Luensmann Offsite Water Main Ext PH1
Solicitation Number: CO-00717
Job No.: 23-1043

ADDENDUM 1
11/16/2023

PLAT NO.	
JOB NO.	12473-09
DATE	MARCH 2023
DESIGNER	CD
CHECKED	MP DRAWN CD
SHEET	C3.13

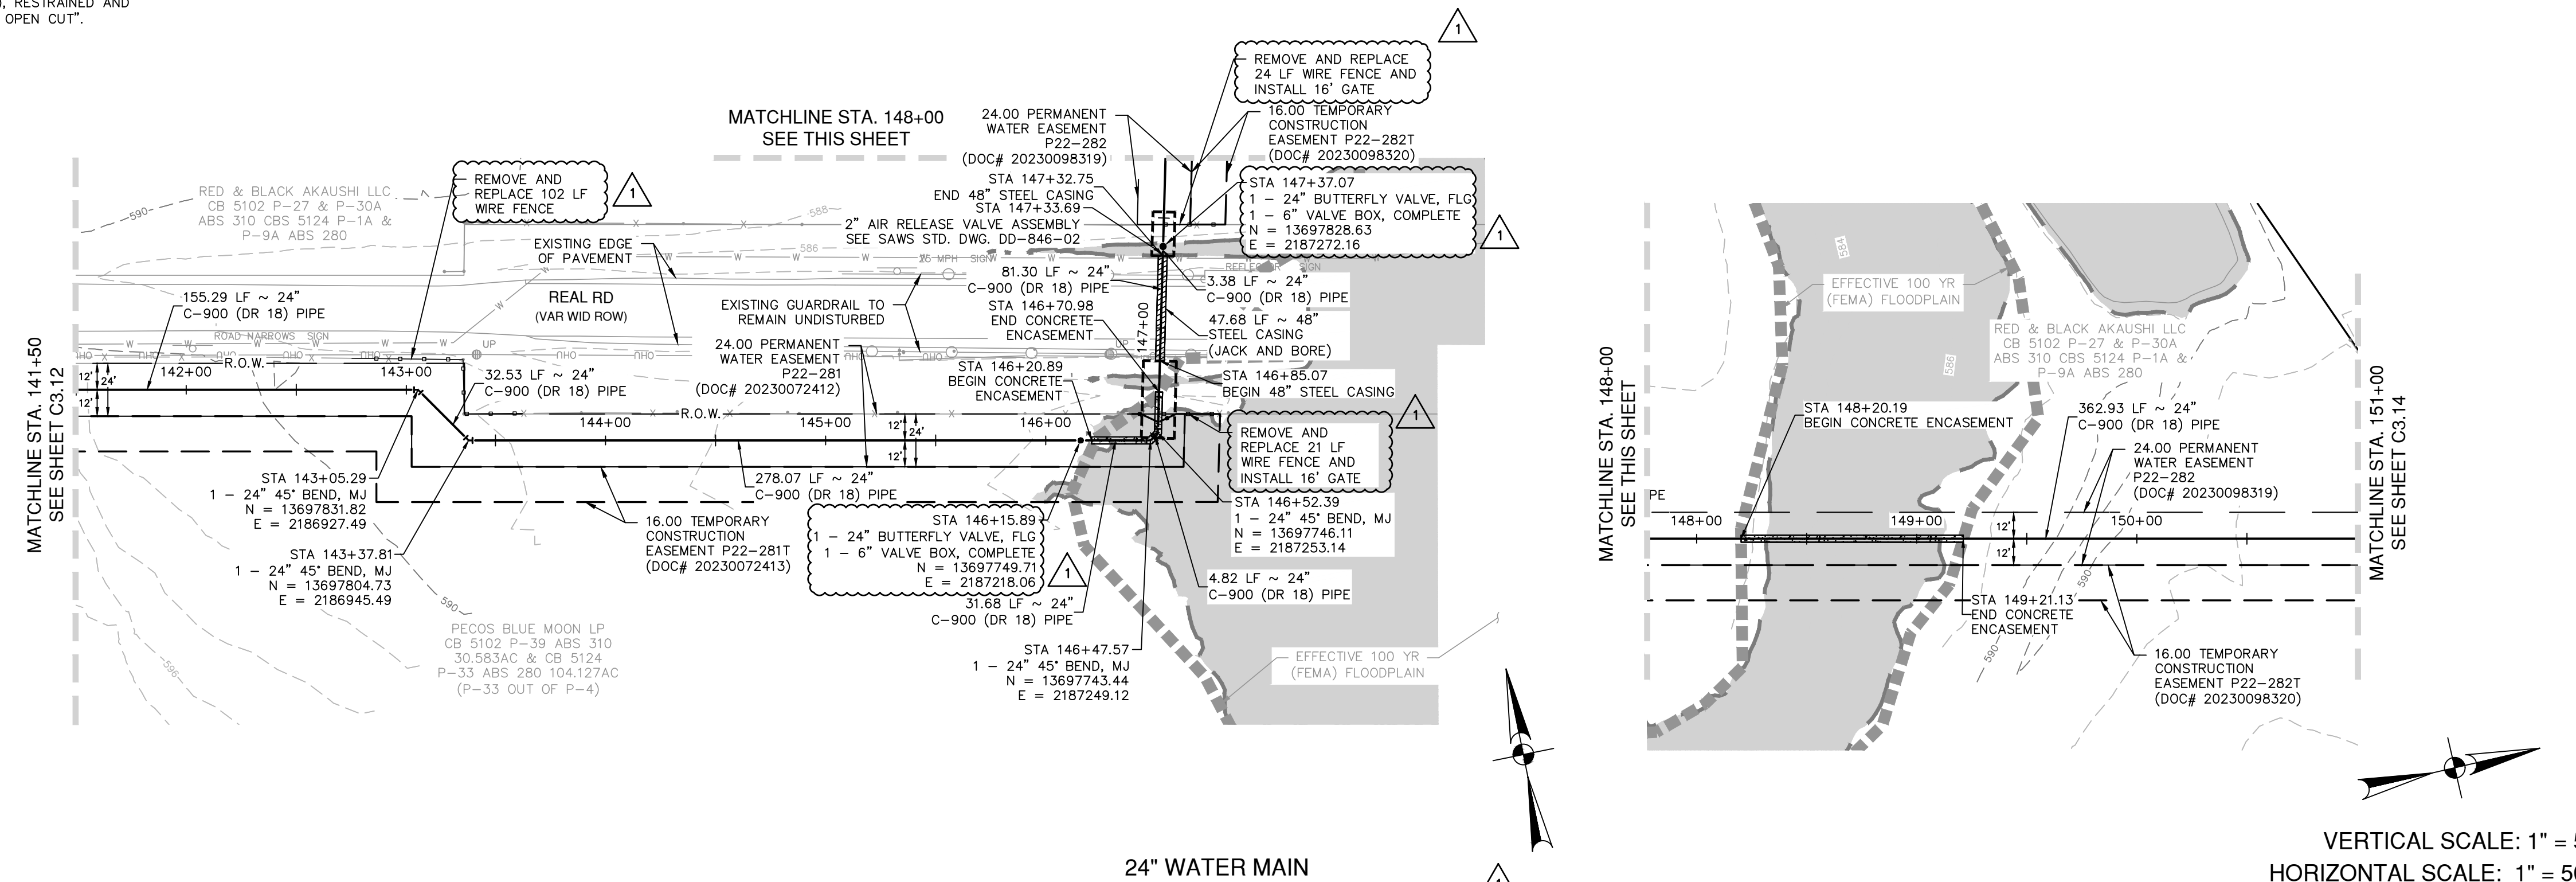
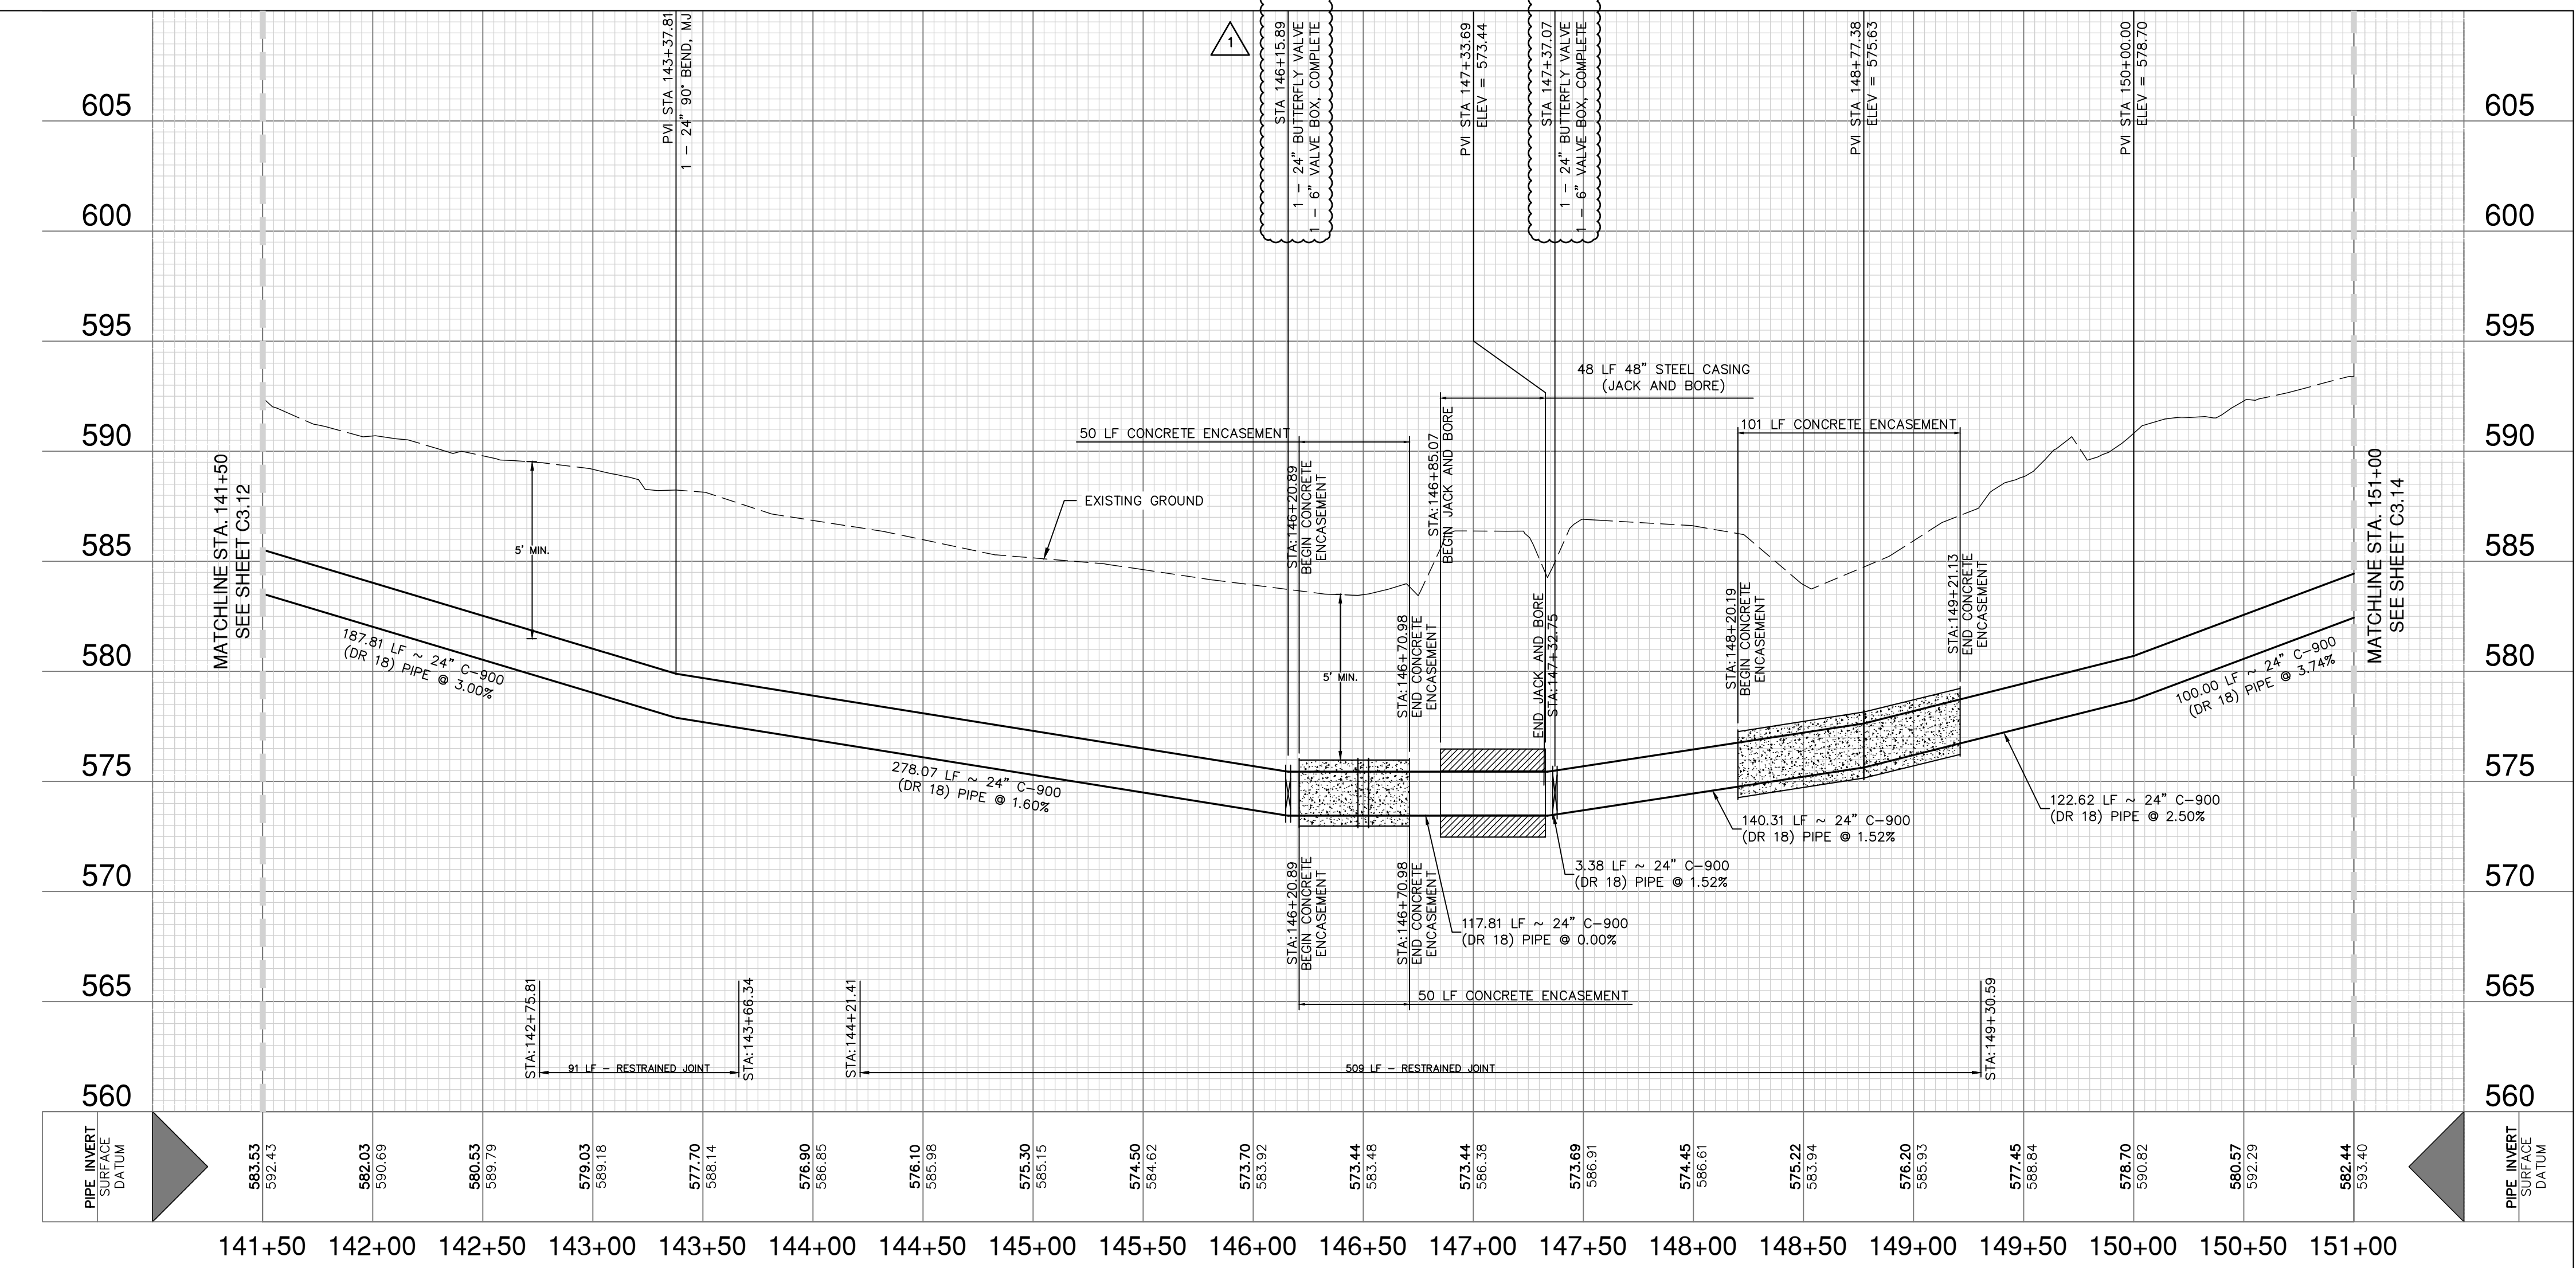
- Updated quantity table to add a Fence Gate Type 1 and Remove and Replace Existing Fence
 - Revised 24" Butterfly valve to be Flanged.
 16. Sheet C3.13: Water Main Plan and Profile Sta 141+50 to 151+00 – Remove in its entirety and replace with the attached document.
